ADDENDUM NO. 1

**ARCADIA HIGH SCHOOL
LOCKER ROOM ALTERATION
ARCADIA UNIFIED SCHOOL DISTRICT**

tBP/ARCHITECTURE
4611 Teller Avenue
Newport Beach, CA 92660
949-673-0300

This Addendum forms a part of the Contract Documents and modifies the original Bidding Drawings dated August 15, 2024, and Specifications dated July 2024. Acknowledge receipt of this Addendum in space provided on the Bid Form. Failure to acknowledge may subject Bidder to disqualification.

E3.1

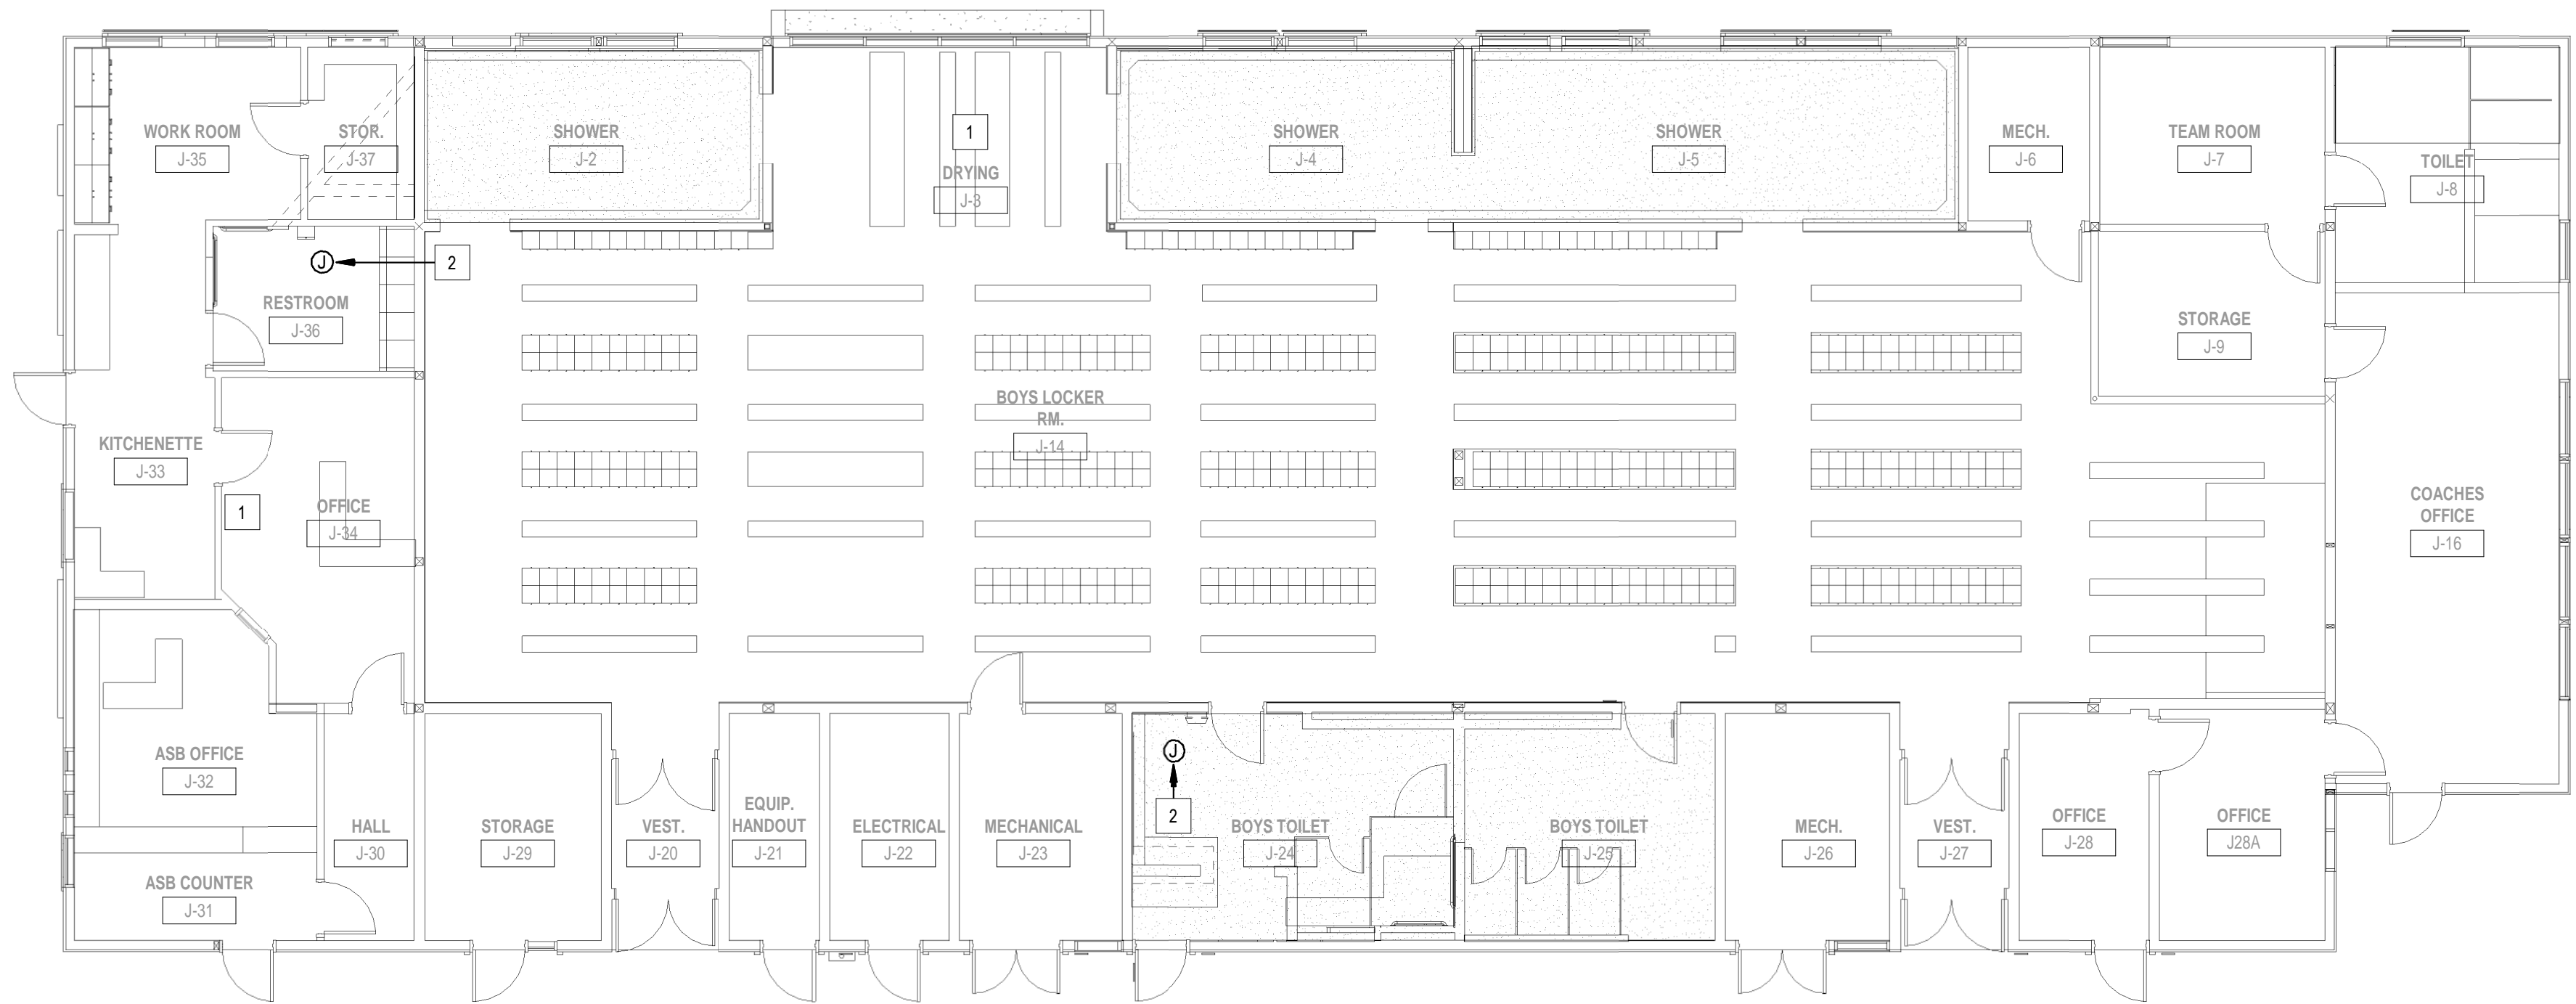
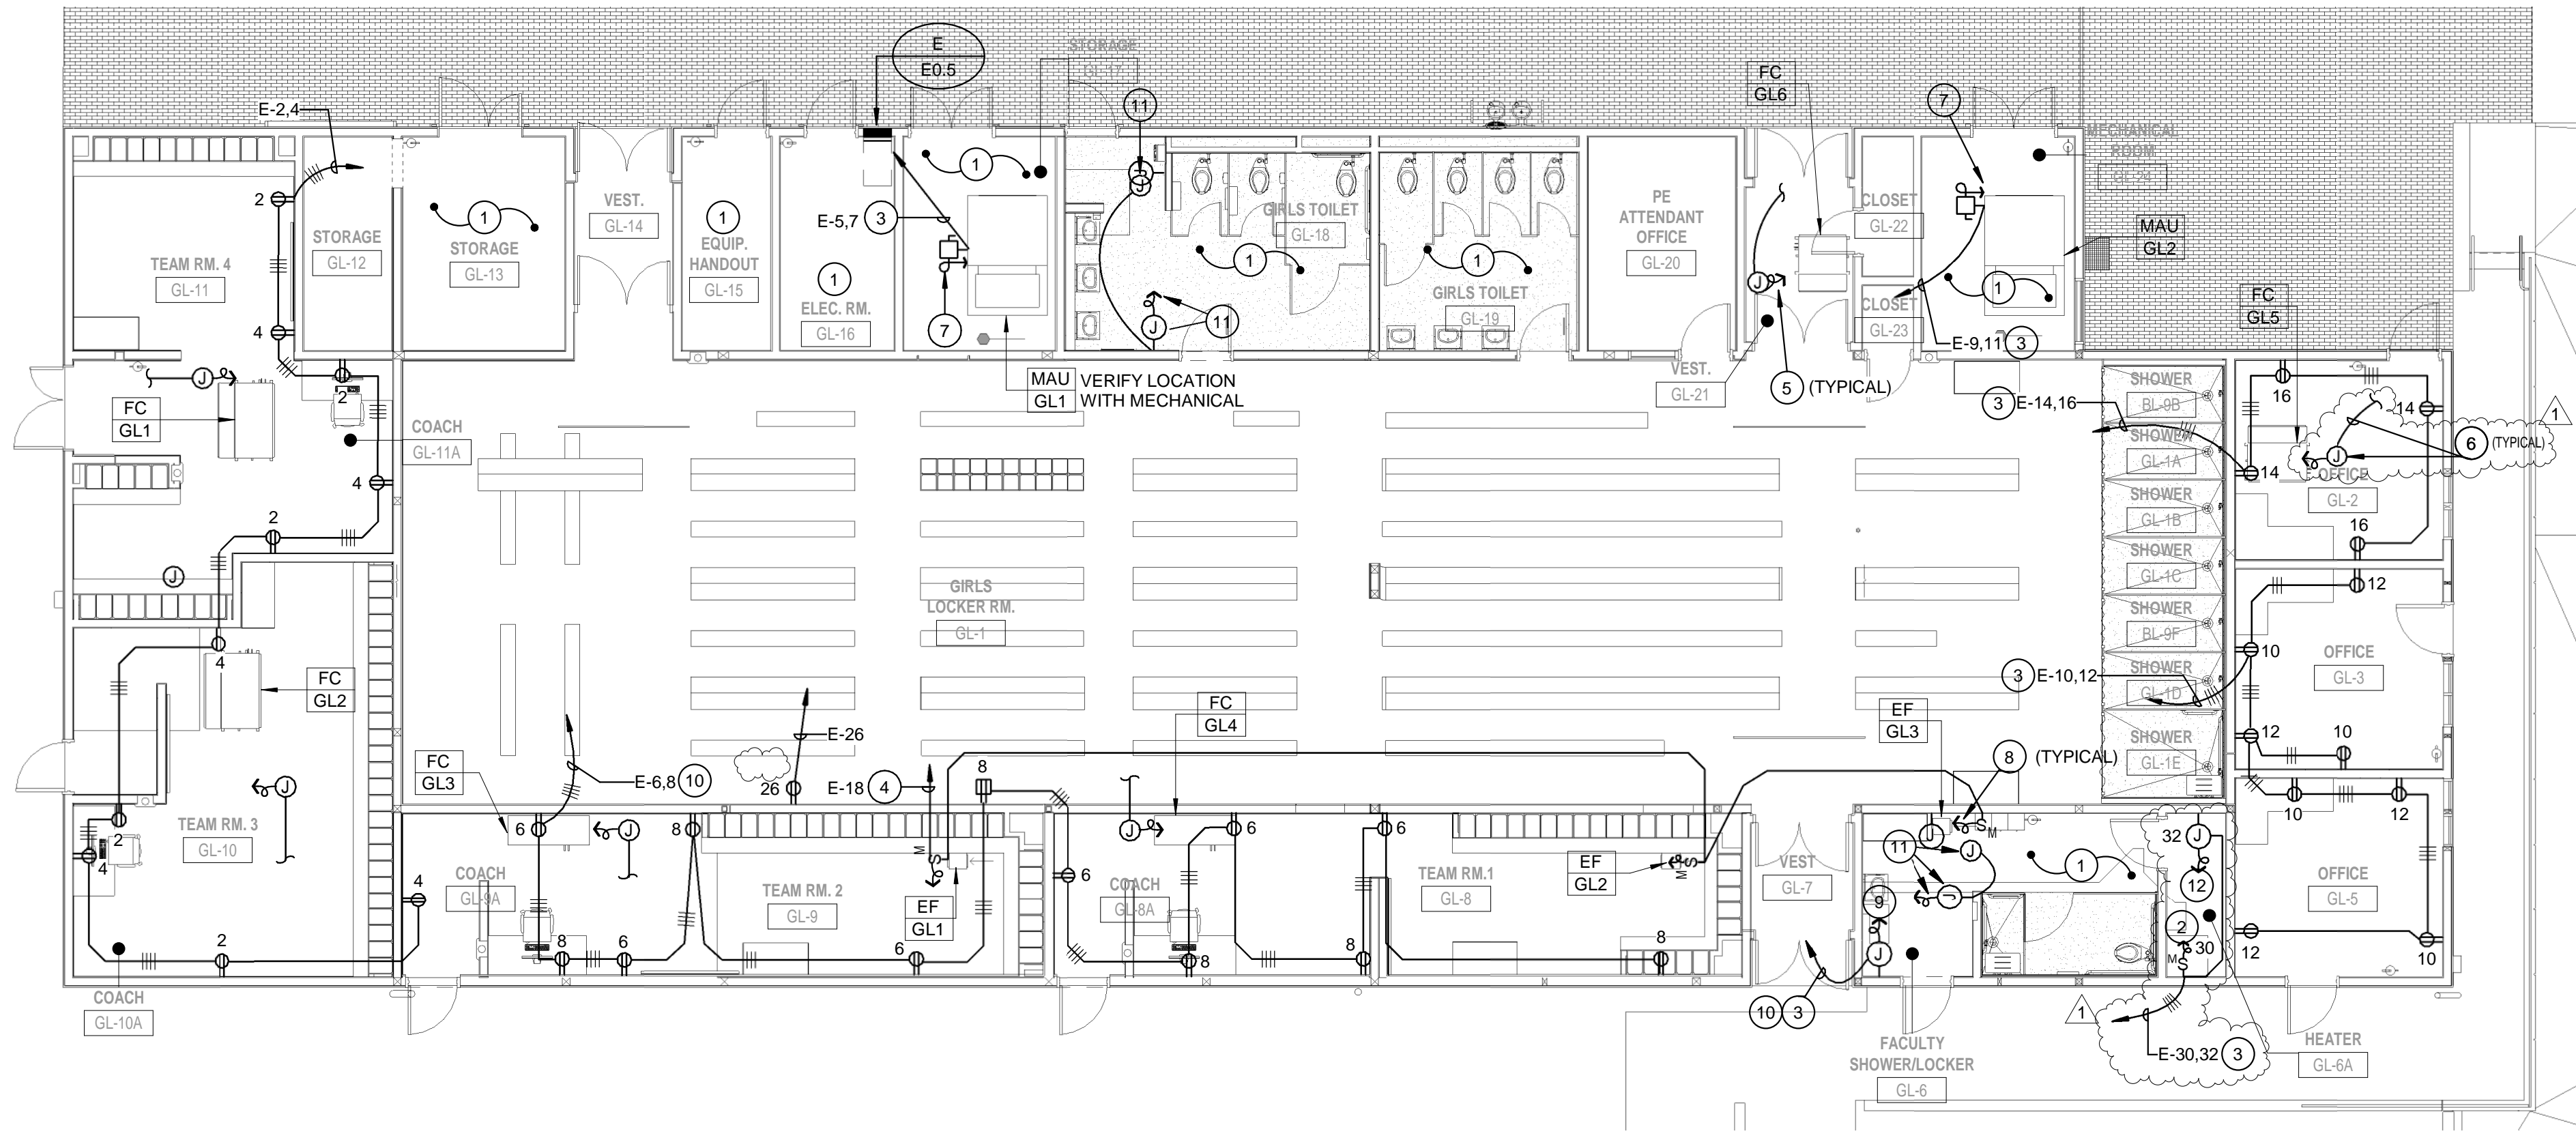
- a. Relocate light fixture in Offices and showers in accordance with architectural plan.
- 28. SHEET E3.1 – BUILDING BL POWER PLAN
Replace full size sheet drawing **E3.1** in its entirety, issued with this addendum.
Changes include:

- c. Add GFI outlets in All Gender Restroom BL-9.
- 29. SHEET E3.2 – BUILDING GL POWER PLAN
Replace full size sheet drawing **E3.2** in its entirety, issued with this addendum.
Changes include:

E4.1

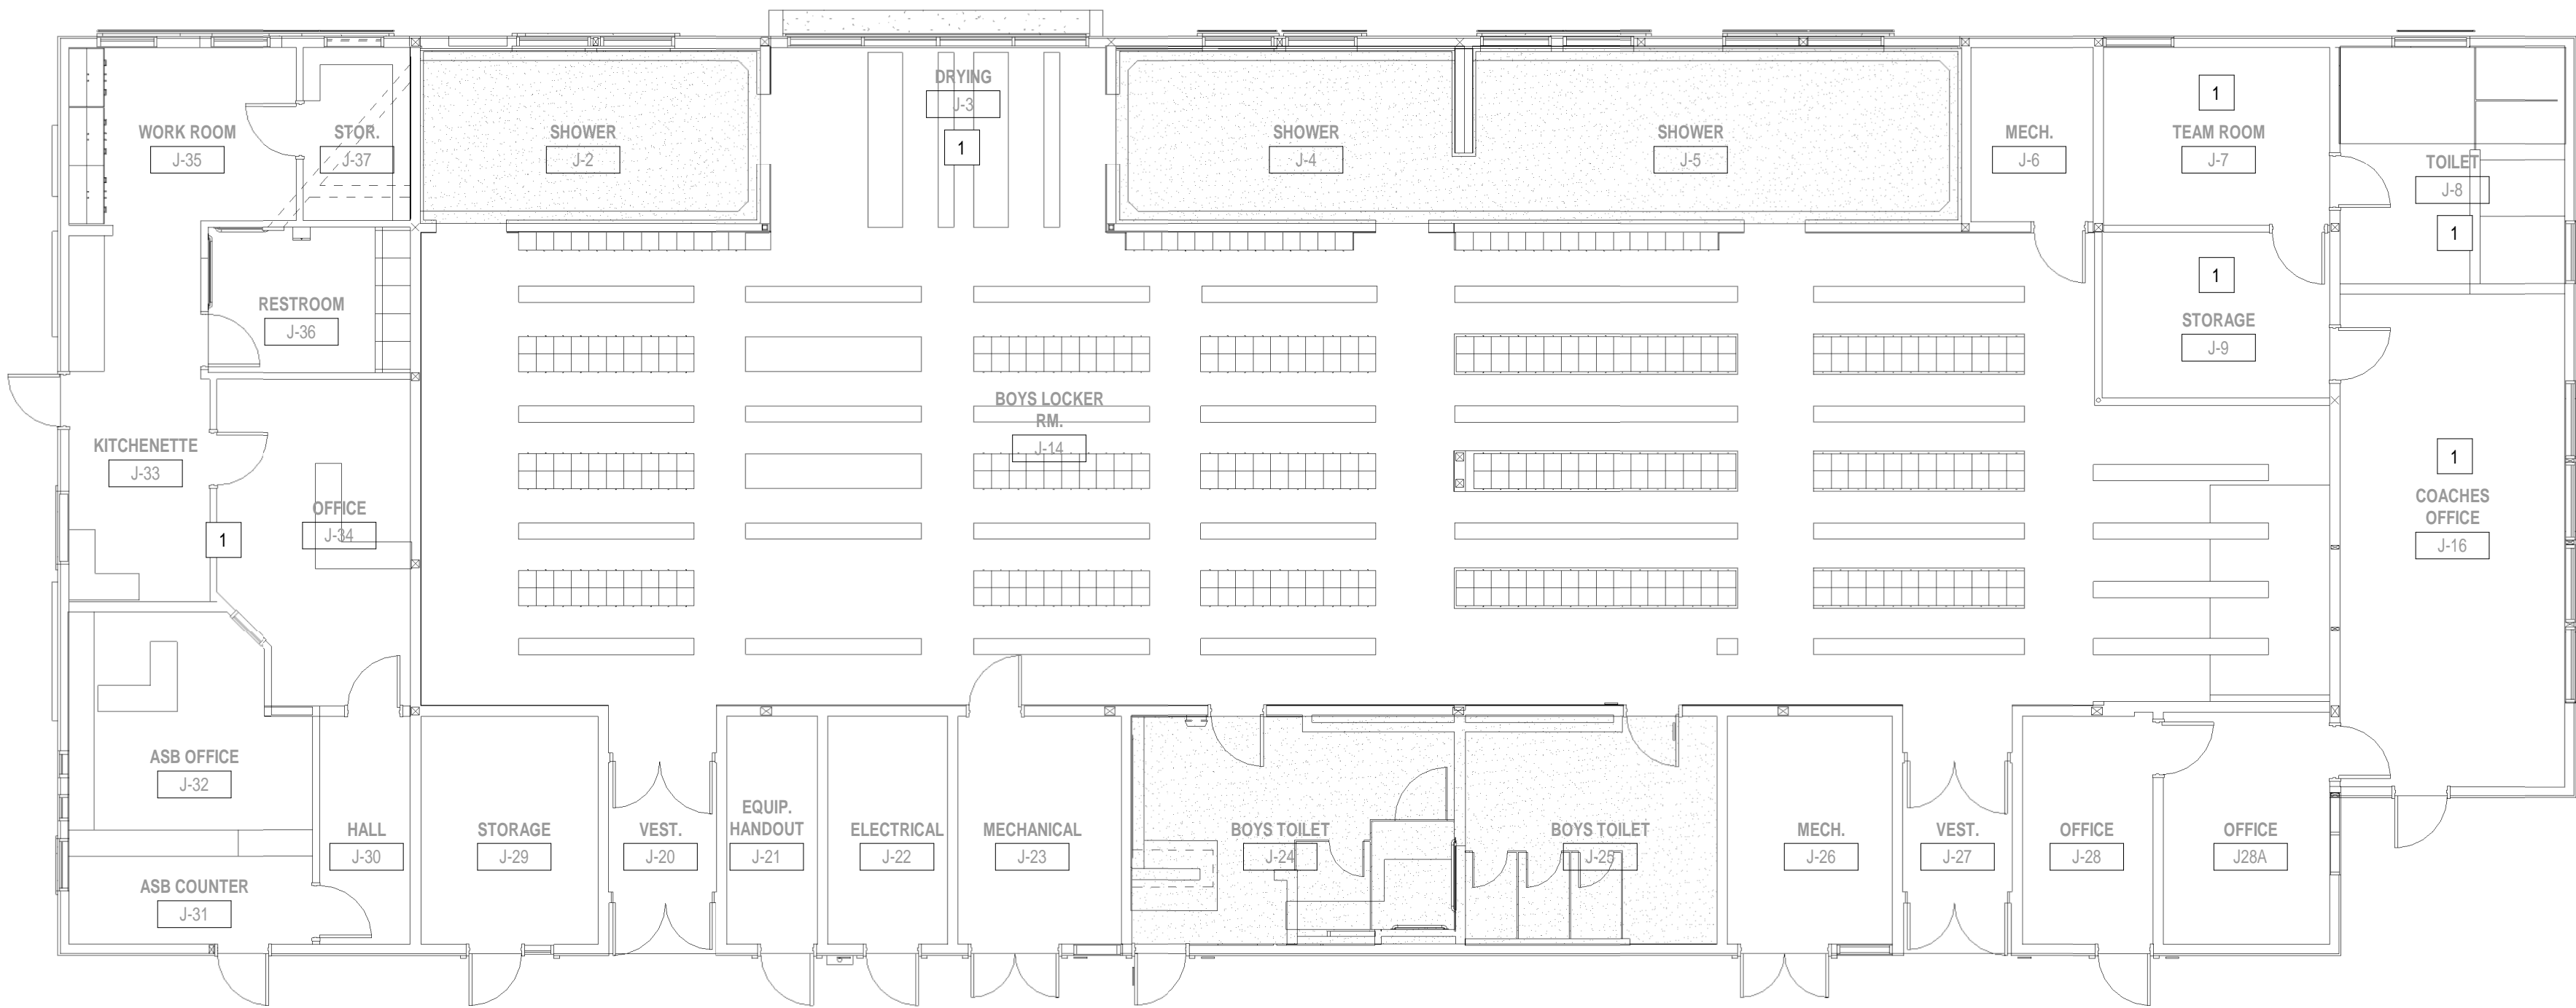
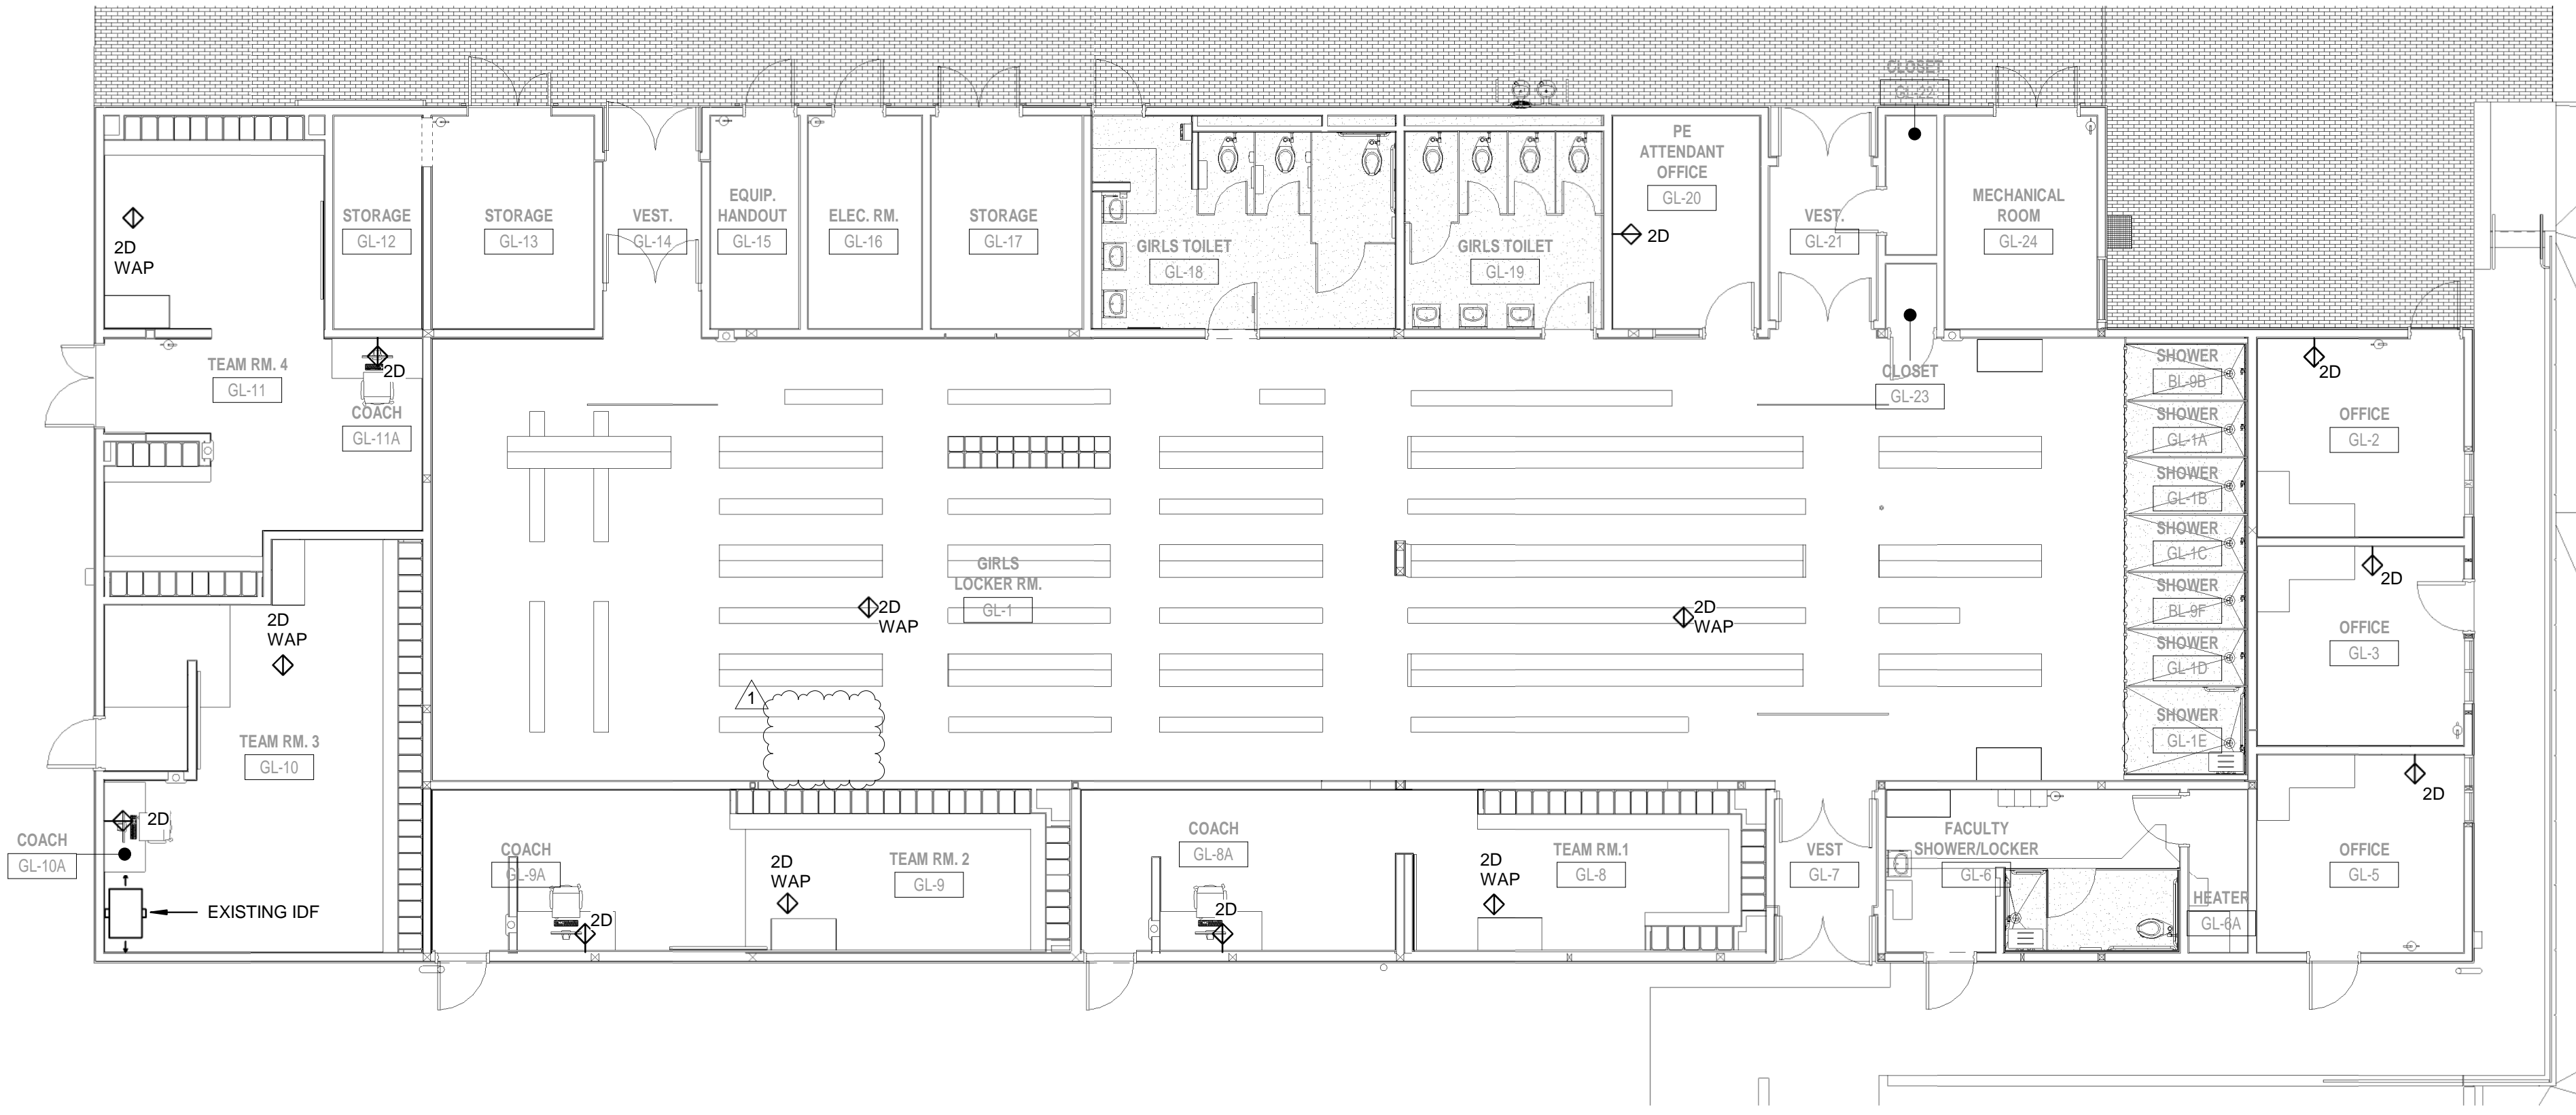
30. SHEET E4.1 – BUILDING BL SIGNAL PLAN
Replace full size sheet drawing **E4.1** in its entirety, issued with this addendum.
Changes include:
 - a. Remove audio/video and data outlet in Locker Room BL-1.
